**From:** Kosky, Ken [KKosky@GOLDER.com]  
**Sent:** Tuesday, August 12, 2003 9:55 AM  
**To:** Heron, Teresa  
**Cc:** Farzie Shelton (Farzie.Shelton@lakelandelectric.com)  
**Subject:** Lakeland Electric Larsen Unit 8

**RE: DEP File No. 105003-008-AC; PSD-FL-166(D)  
Lakeland Electric, Charles Larsen Power Plant  
Combined Cycle Unit 8 – Peak Operation and Turbine Upgrades**

RE: DEP File No. 105003-008-AC; PSD-FL-166(D)  
City of Lakeland, Charles Larsen Power Plant  
Combined Cycle Unit 8 – Peak Operation and Turbine Upgrades  
Request for Information

Re: DEP File No. PSD-FL-166(D) and 1050003-<sup>012</sup>~~008~~-AC  
Charles Larsen Memorial Power Plant – Combined Cycle Unit 8  
Increase of Heat Input Rate and Peak Mode Operation Request

# ***Frame 7 Advance Technology Uprate***

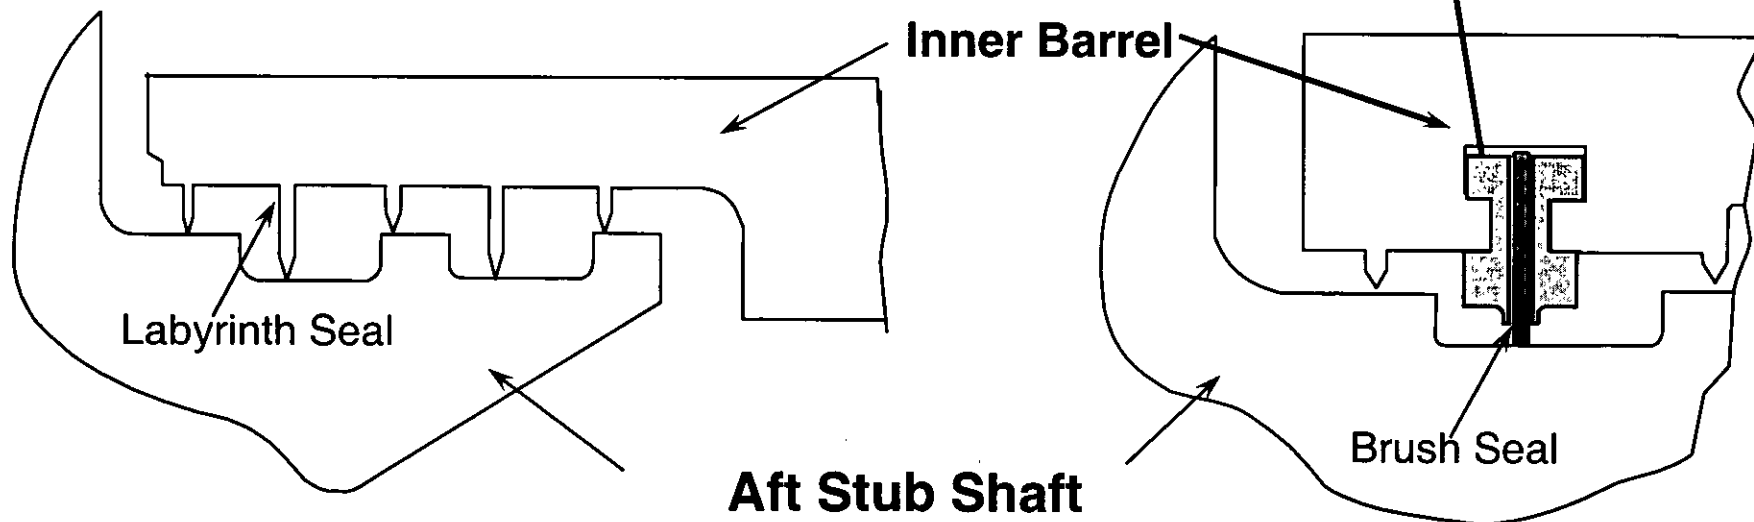
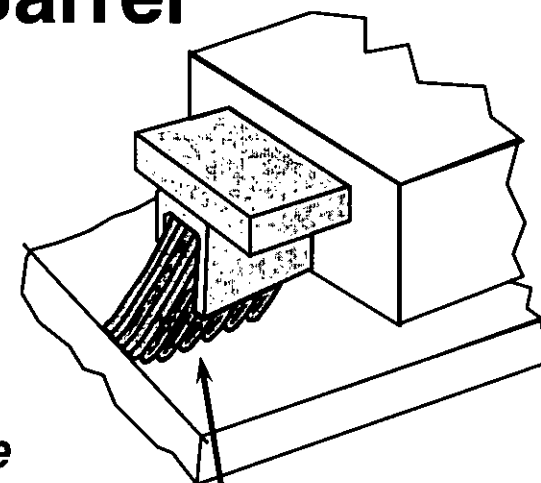
3. Expand the technical information regarding the upgrade of this unit, the information in the application states that the upgrade "involve enhancements to the compressor discharge (high pressure brush seal) that limit the amount of air leakage". Please submit GE technical documents that explain this issue. Is the Low NOx burner (LNB) system being upgraded? Could it be possible to upgrade the LNB system along with the proposed upgrade?

3. **Technical Upgrades:** As stated in the air permit application, the upgrades involve a GE proprietary enhancement in the design of the high-pressure seals of the compressor discharge. A high-pressure brush seal has been added to the existing Labyrinth seal design to minimize air leakage from the compressor to the combustor (see attached figure). This allows more air into the combustor and exhaust turbine, which slightly increases the performance turbine. This change does not affect the combustion turbine's automatic control system, fuel system logic, or the water injection system for NO<sub>x</sub> control. However, as stated in the air permit application, the increase in performance is theoretical and GE will not guarantee the performance since the turbine has been operated for about 10 years. The existing combustor uses water injection for NO<sub>x</sub> control, and upgrade to the dry low-NO<sub>x</sub> (DLN) combustor cannot be made.

- Minimize Air Leakage
- Tolerant of Misalignments
- More Durable than Labyrinth Seals

***NOTE: New unit production 71EAs have a honeycomb seal on the inner barrel with labyrinth teeth on the aft stub shaft. For this configuration, a new inner barrel is supplied with a brush seal in addition to the honeycomb seal.***

**GE PERFORMANCE DATA FOR  
PG7111(EA) GAS TURBINE**

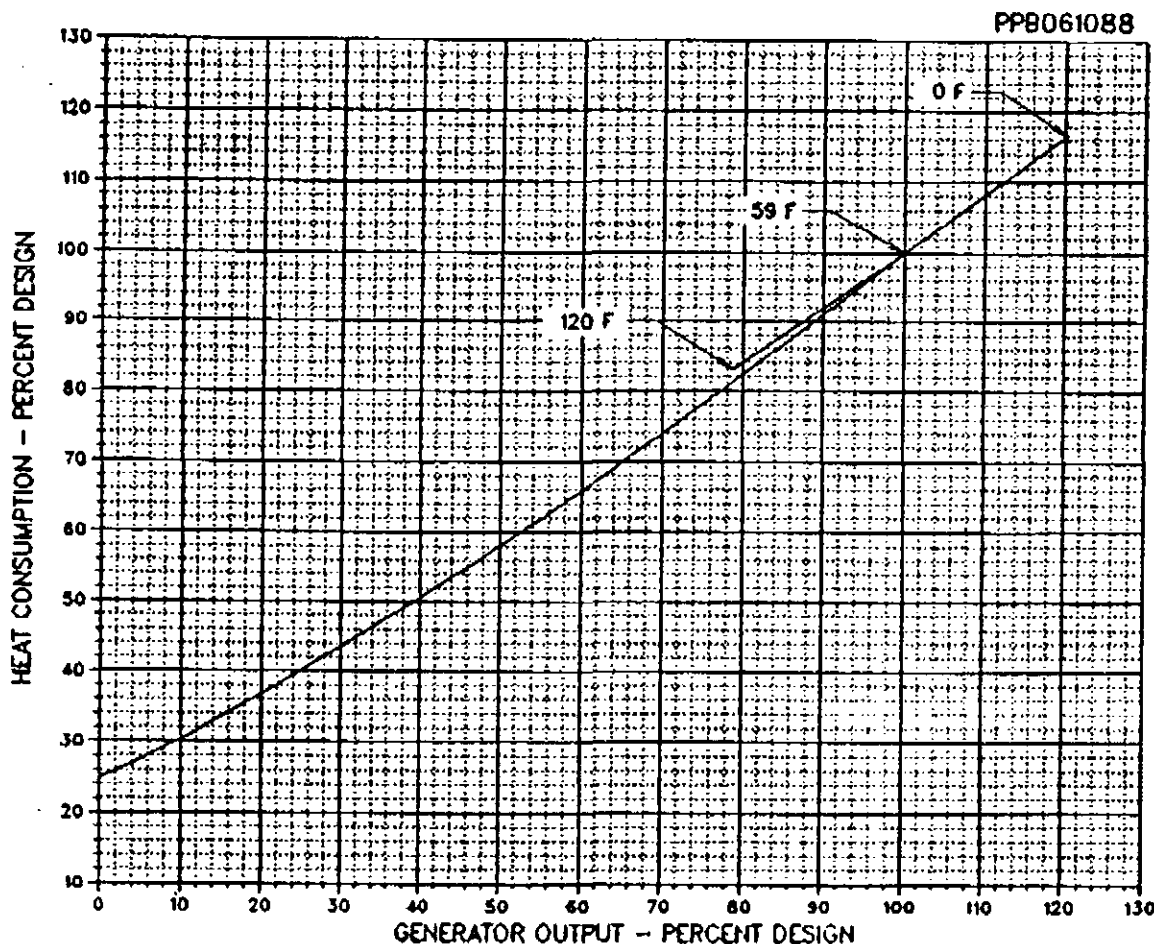
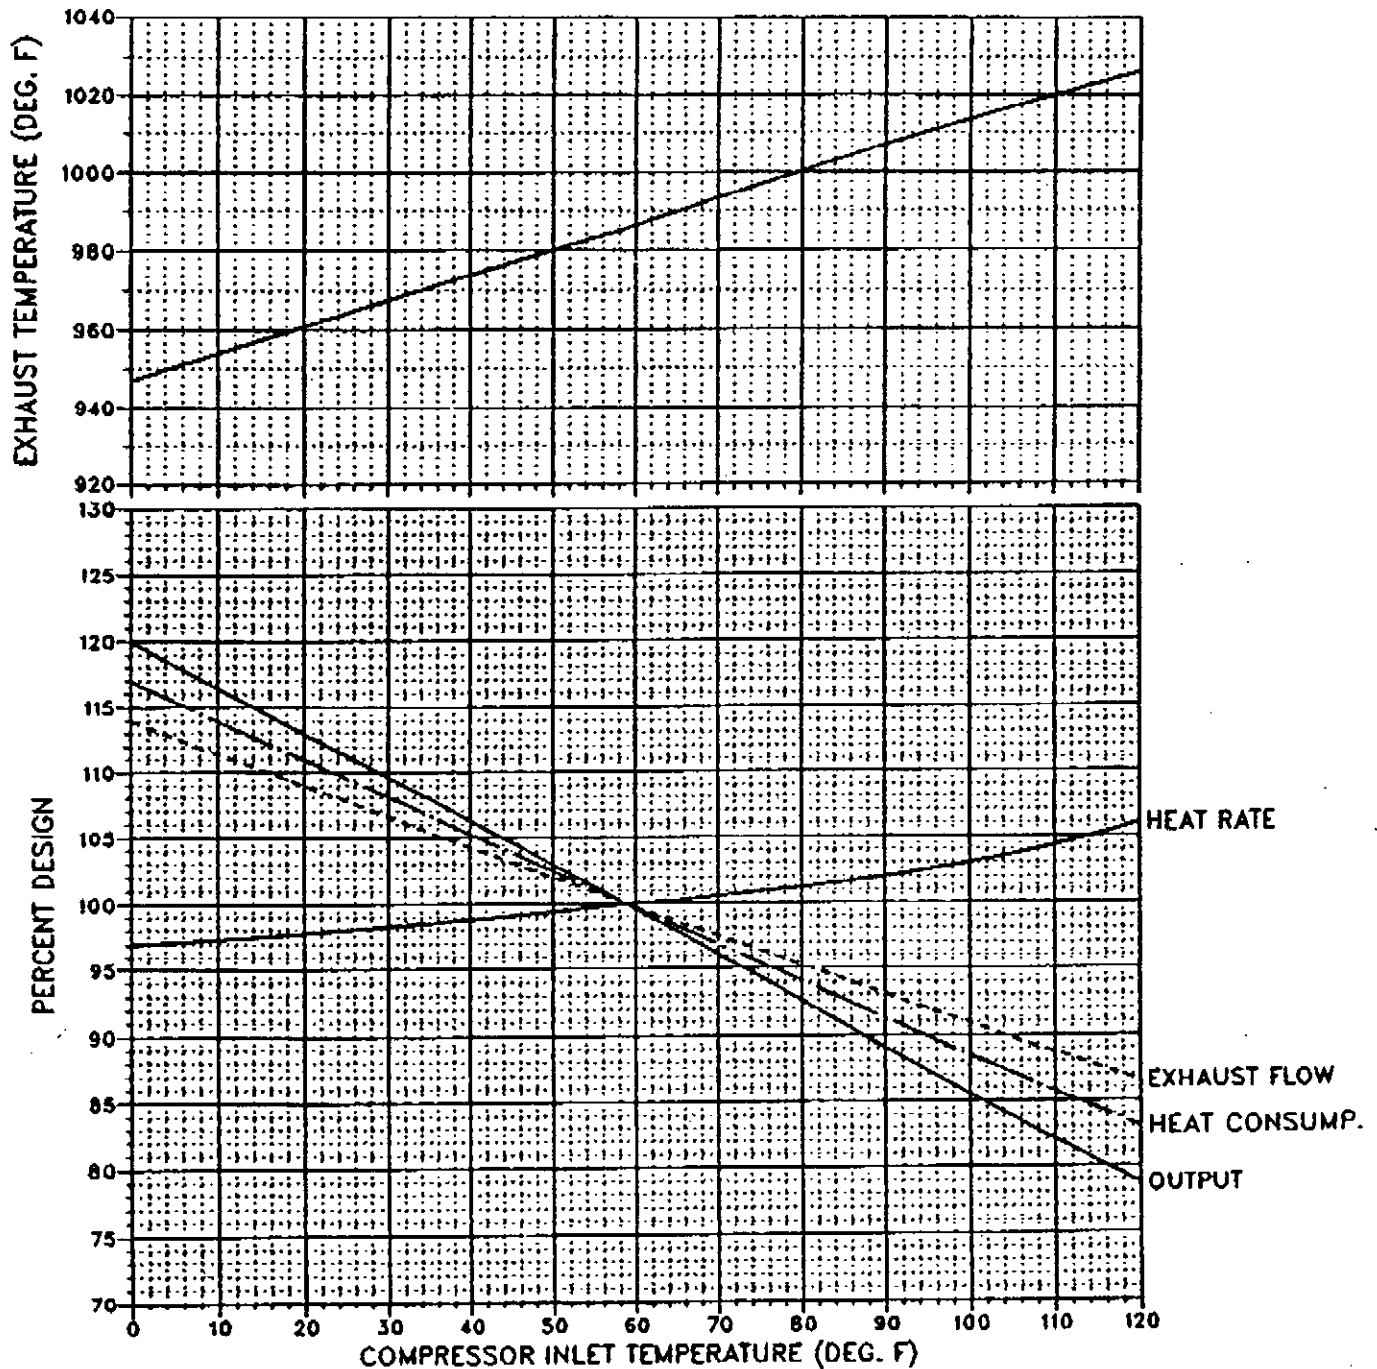
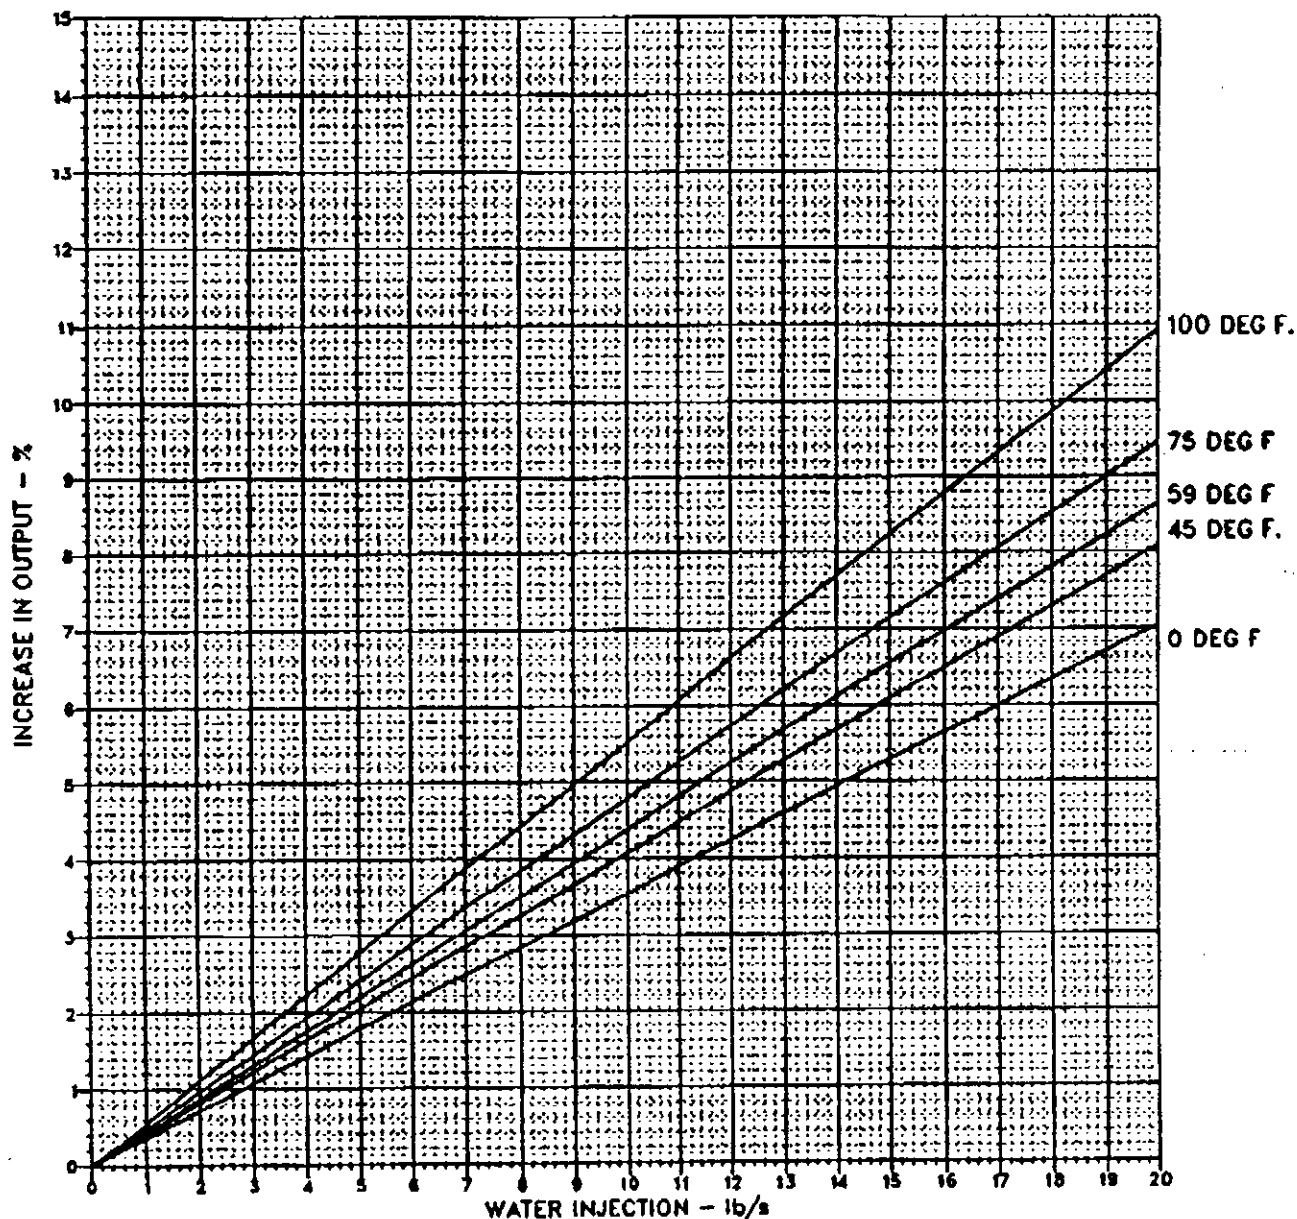
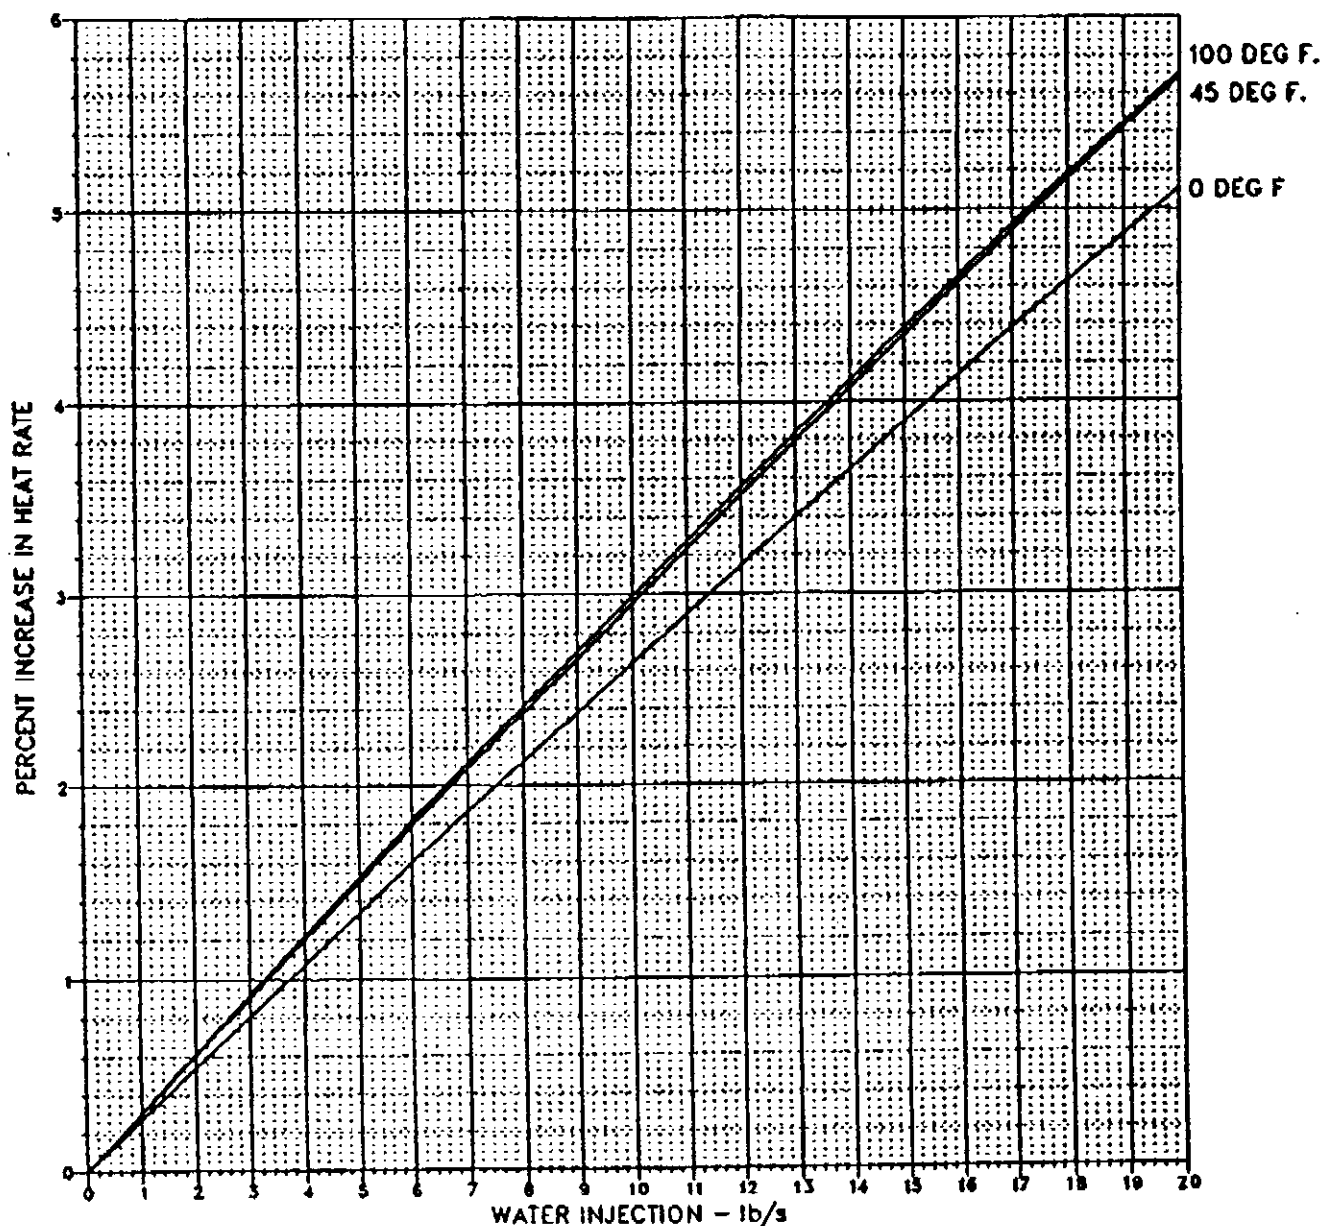
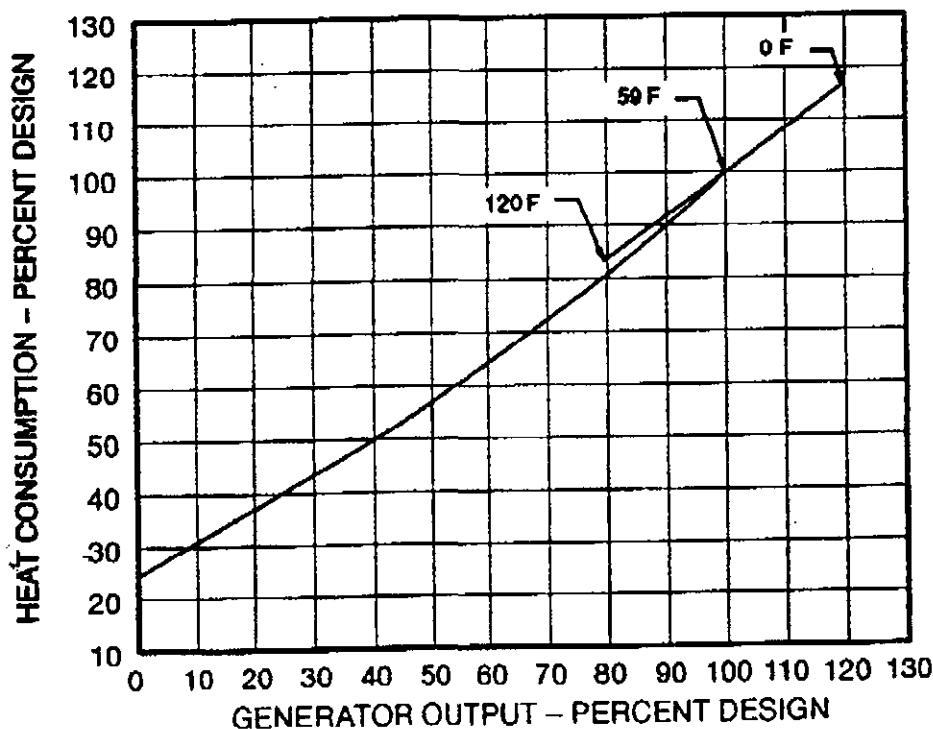
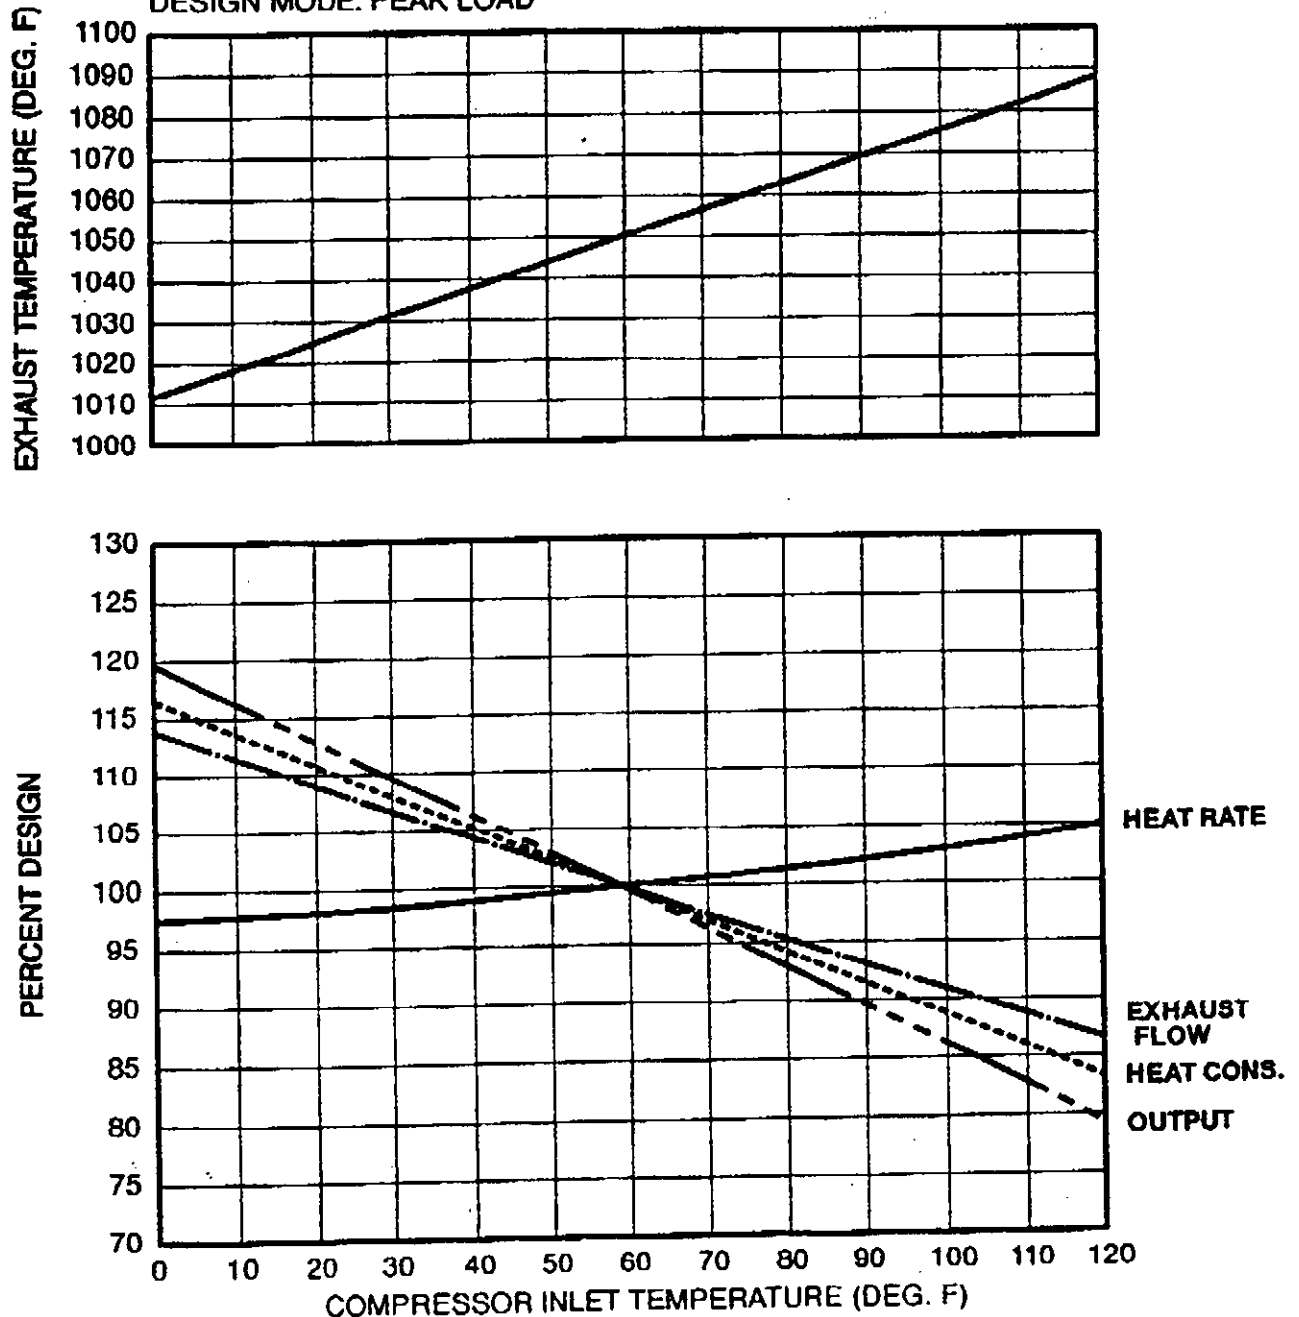
4. Please supply the manufacturer's specifications for the GE Model PG 7111EA.

4. **GE Model PG 7111EA Specifications:** The GE performance curves for the PG 7111EA combustion turbine operating in both baseload and peak mode are attached. As noted by the

dates of these curves, Peak Mode operation was included in the original design of Unit 8.  
The heat input limit in the original permit however reflected baseload operation.
